ECN/PCN No.: M1198

For Manufacturer			
Product Description: <div style="text-align: center; color: #0056b3;">SMT Air Coil Inductor</div>	Abracon Part Number / Part Series: <div style="text-align: center; color: #0056b3;">AIAC-1812 Series</div>	<input type="checkbox"/> Documentation only <input checked="" type="checkbox"/> ECN <input type="checkbox"/> EOL	<input checked="" type="checkbox"/> Series <input type="checkbox"/> Part Number(s)
Affected Revision: <div style="text-align: center;">G</div>	New Revision: <div style="text-align: center;">H</div>	Application:	<input type="checkbox"/> Safety <input checked="" type="checkbox"/> Non-Safety

4.0 Part Number Identification

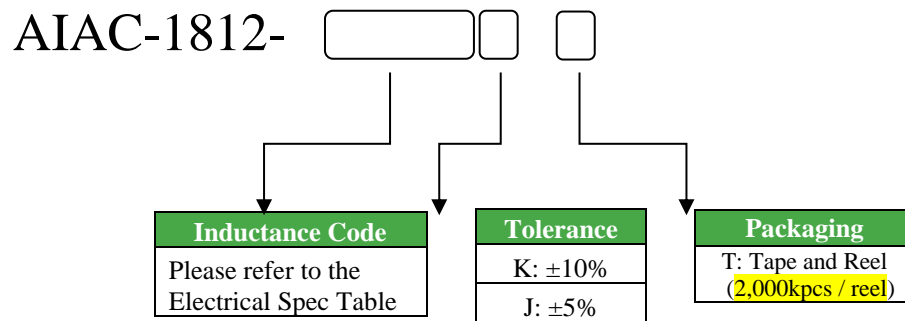
Prior to Change:

8.0 Packaging

T: 2,000pcs / reel

4.0 Part Number Identification

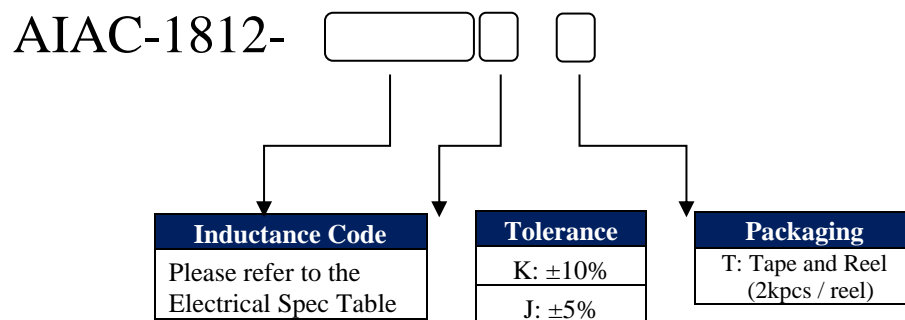
Cause/Reason for Change: Qty/Reel is erroneously stated as 2000Kpcs for the series. Correct to 2Kpcs/reel.		
Change Plan		
Effective Date: 11/06/2020	Additional Remarks:	
Change Declaration: The changes described in this ECN do not negatively impact the products form, fit or function.		
Issued Date: 11/06/2020	Issued By: <i>Gerald Capwell</i>	Issued Department: Engineering
Approval: <i>Syed Raza</i> Engineering VP	Approval: <i>Reuben Quintanilla</i> Quality Director	Approval: <i>Ying Huang</i> Purchasing Director
For Abracon EOL only		
Last Time Buy (if applicable):		Alternate Part Number / Part Series:
Additional Approval:	Additional Approval:	Additional Approval:
Customer Approval (If Applicable)		
Qualification Status: <div style="text-align: center;"> <input type="checkbox"/> Approved <input type="checkbox"/> Not accepted </div> <i>Note: It is considered approved if there is no feedback from the customer 1 month after ECN/PCN is released.</i>

8.0 Packaging

T: 2Kpcs / reel
